**PSA Request C207 – 272-280 Normanby Rd, SM – 20 Levels
Internal Referral Responses to Application (May 2022) Plans**

07 JUNE 2022
CITY STRATEGY TEAM REFERRAL ADVICE

- Proposed section 20(4) Amendment to the Port Phillip Planning Scheme
- 272-280 Normanby Road, South Melbourne (with Johnson Street Park Proposal)

Swept path analysis:

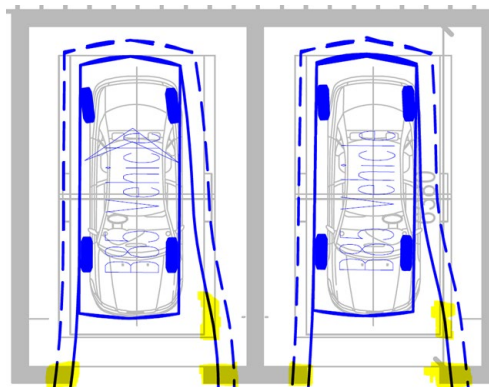
- Swept paths show a B85 vehicle entering and exiting the car lift. The lift access points need to be adequately widened to not encroach into the 300mm clearance area. As currently proposed, the vehicle will hit the lift entry point. Further, the applicant is to confirm the suitability of the vehicle envelope when driving on the lift platform. An easy to access lift is important based on the assumption of a 10 second entry and exit time.

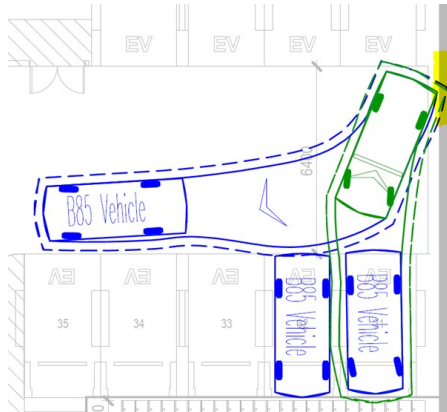
Parking aisle walls at dead-end spaces have not been adequately designed. See below.

- It is unclear if clearances at blind aisles (dead-end spaces) have been provided in accordance with the standards. The swept path diagram shown in Swept Path Analysis indicates that the parking aisle wall offset is not adequate, and the 300mm vehicle clearance encroaches over the parking aisle wall.
- One accessible parking space is proposed for the development. The development comprises of various commercial uses and has not detailed the requirements of the BCA for each use where parking is provided. An analysis of the BCA for accessible parking spaces is to be provided to ensure the amount of accessible parking spaces proposed are in-line with the requirements of the BCA.
- The development is required to provide 4 motorbike spaces onsite. The architectural plans show provision of 4 motorbike spaces within each parking level.

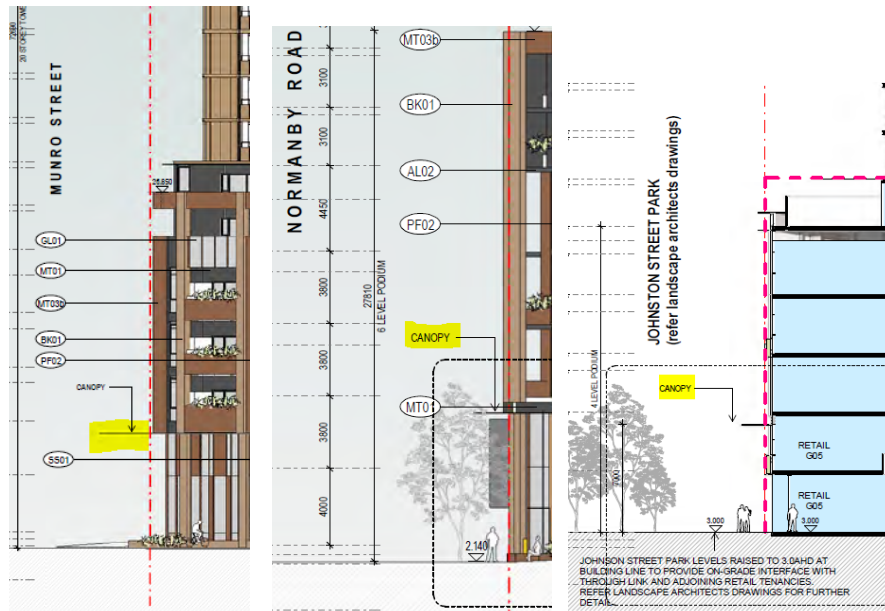
- From a drainage perspective, as the water falling on the proposed canopy below (MTO2) can drip on the pedestrians which can cause a nuisance, hence, water falling on these features need to be captured and conveyed to the legal point of discharge.
- In addition to above, from a safety perspective, these features need to be designed to withstand the various dynamic load acting on canopy and its connection to the building or wall so that it doesn't fail and fall.

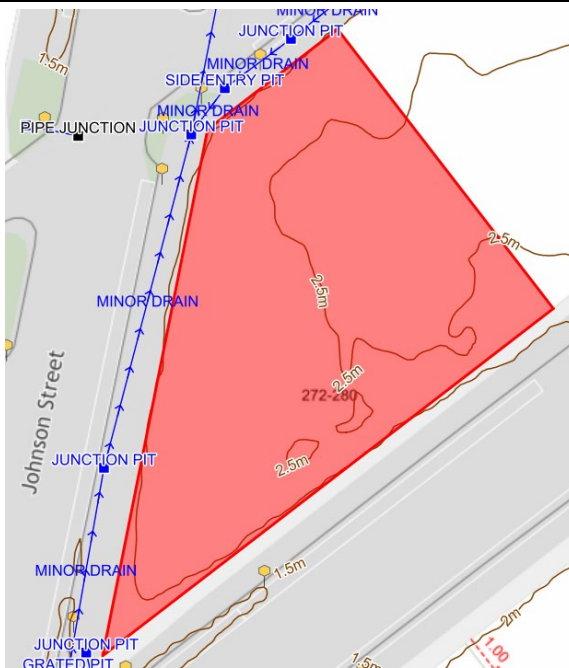
- The wall projection highlighted below should not encroach onto the public realm and be constructed within the property boundary.
